# UNITED STATES PATENT AND TRADEMARK OFFICE

APPLICATION NO.	FILING DATE	FIRST NAMED INVENTOR	ATTORNEY DOCKET NO.	CONFIRMATION NO.
10/088,575	05/10/2002	Michel Bremont	RAG-14302/08	4825
25006	7590	03/07/2005	EXAMINER	
GIFFORD, KRASS, GROH, SPRINKLE & CITKOWSKI, P.C PO BOX 7021 TROY, MI 48007-7021			MAKI, STEVEN D	
			ART UNIT	PAPER NUMBER
			1733	
DATE MAILED: 03/07/2005

# Office Action Summary

Figure A

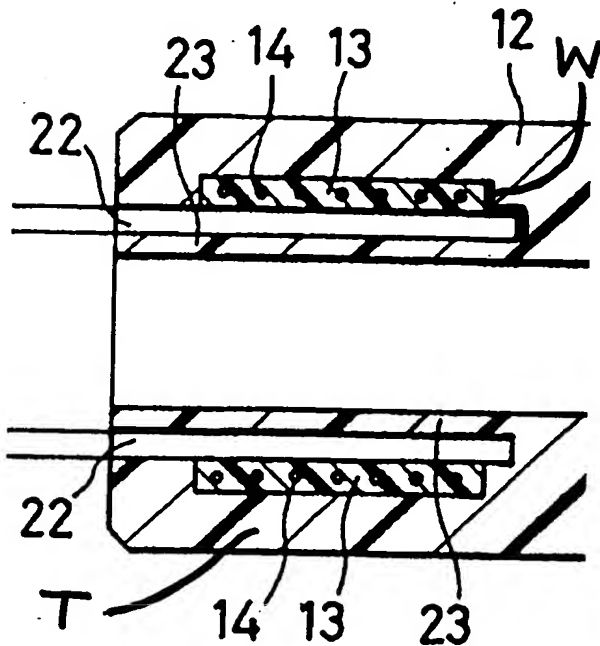
In figure A, the reference letters W and T in the above figure A were added by the examiner. The reference letter T indicates the "outer tube". The reference letter W indicates the "connecting wall". The surface of the "connecting wall" W has been darkened by the examiner in the above enlargement of figure 4 to facilitate discussion of figure 4. In figure B, the darkened lines (bold face lines) indicate the inner surface of the "annular gap".

With respect to the "connecting wall", the surface of the connecting wall W interconnects the rear end of the "outer tube" T and the rear end of the "inner tube" 23.

The claimed connecting wall reads on this "connecting wall" of Nakashiba et al. It is acknowledged that the surface of "connecting wall" in figure 4 of Nakashiba et al comprises two vertical sections connected together by a horizontal section. However, the claimed connecting wall reads on a connecting wall having, in cross section along the axis of the tubes, a non-linear (stepped) surface facing the annular gap. In other words, the claimed tubular coupling element fails to require a connecting wall defining a *flat* surface, which extends *linearly* from an inner cylindrical surface of the outer tube to an outer cylindrical surface of the inner tube. Claims 7-13 fail to specify the *shape* of the rear end of the outer tube, the *shape* of the rear end of the inner tube and the *shape* of the connecting wall.
